Village of Bayside
9075 N. Regent Rd.
Architectural Review Committee Meeting
June 18, 2018
Village Hall Board Room, 6:00 pm

**ARCHITECTURAL REVIEW COMMITTEE
AGENDA**

Attention:
Village of Bayside, WI
Architecture Review Committee

<p>PROJECT/SITE OWNER: Veronica and Chris Berge</p> <p>PROJECT ADDRESS: 9037 Pelham Pkwy</p>	<p>PROJECT SUMMARY: Replace 10x10 shed w/ 7x7 shed. Replace 36' long, 5' tall privacy fence.</p>
--	--

Plat of Survey

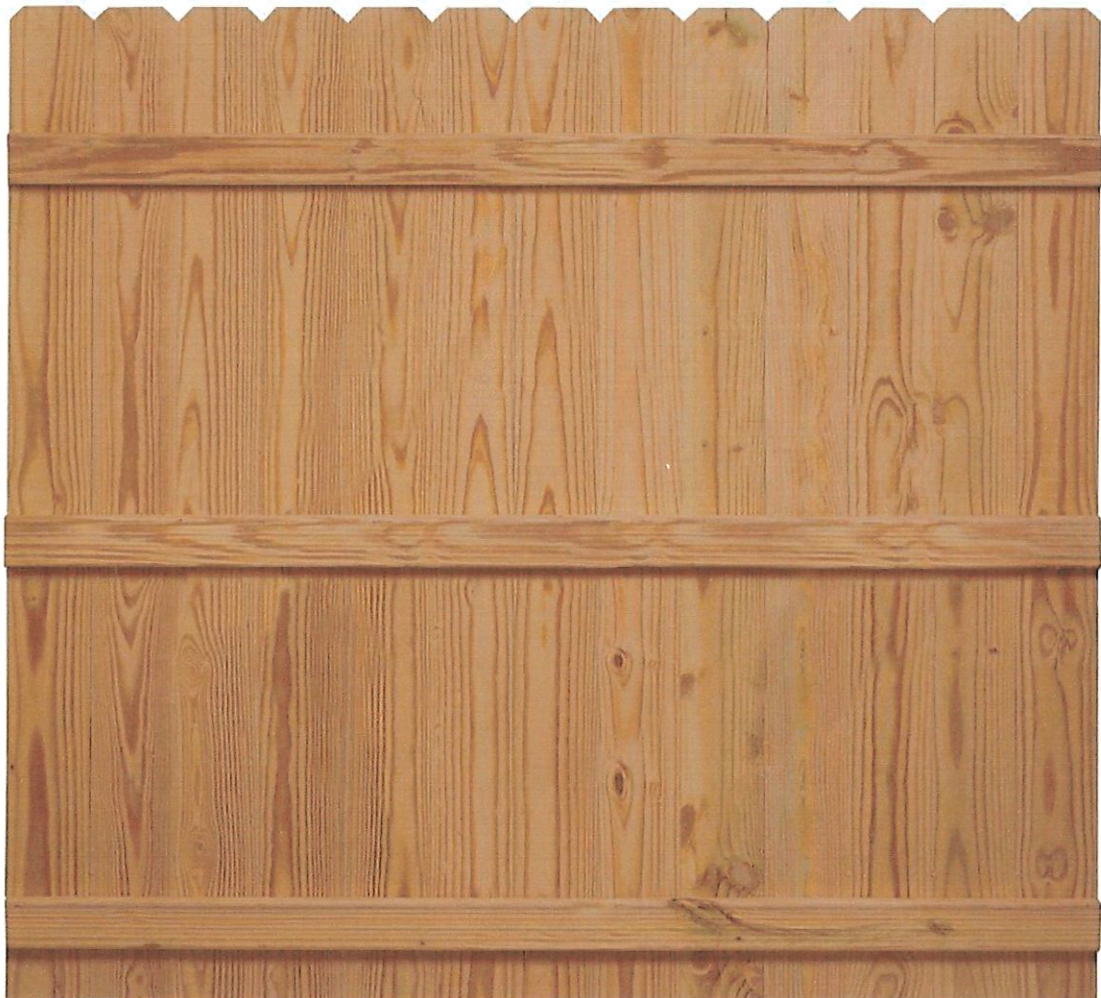
X Exact dimensions are not provided for the location of the new shed. Village code section 125-91 - "C" residence district regulations requires that accessory structures be located a minimum of 10ft from both rear yard and side yard property lines.

VERIFY LOCATION OF SHED IS WITHIN REQUIRED SETBACKS.

PLAT OF SURVEY

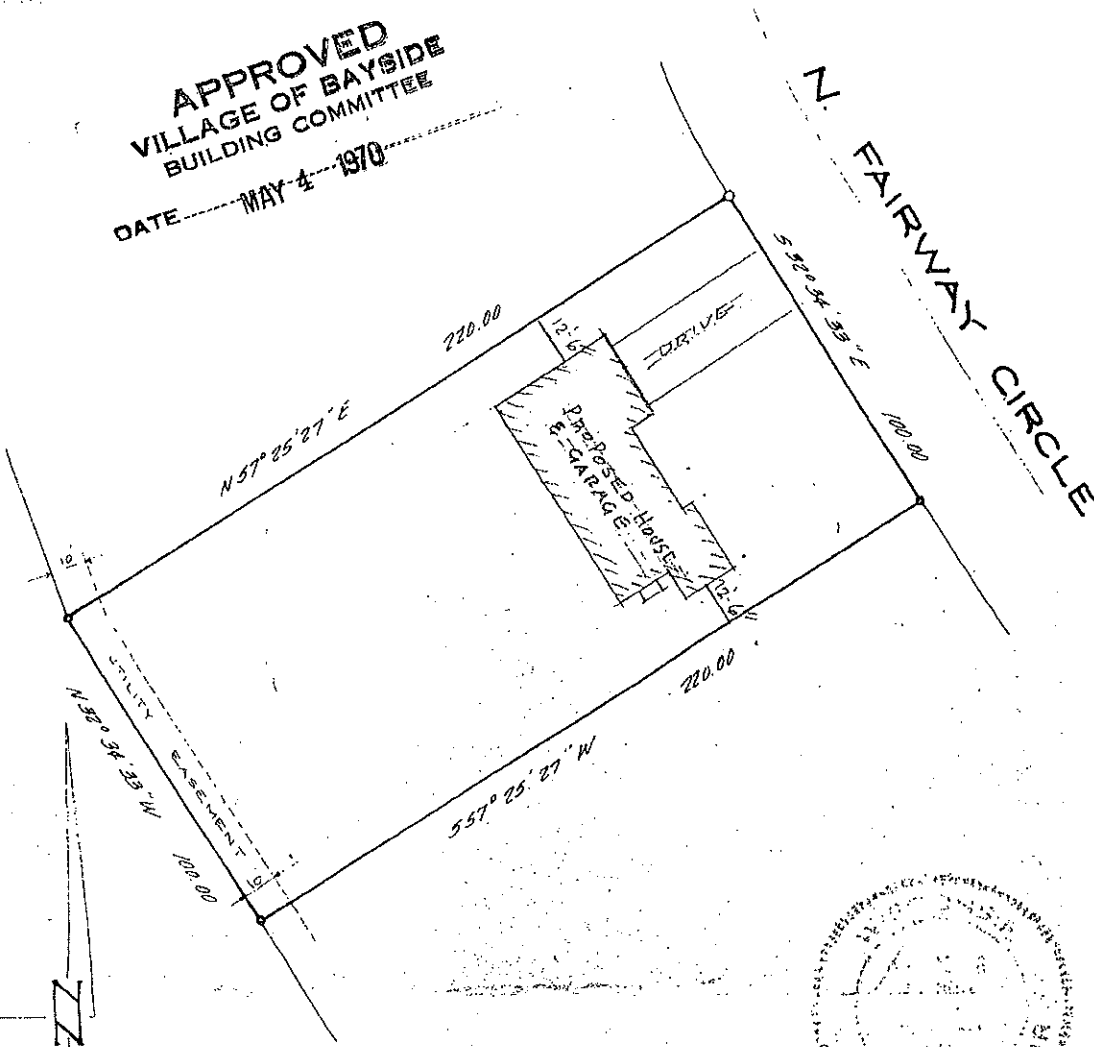
Proposed length of 318' is approximately 50% of the total property perimeter length of approximately 640' and a 50% open design is required by the code section copied below. A privacy fence is proposed which does not comply with the code section below.

PROPOSED LENGTH AND TYPE DO NOT COMPLY
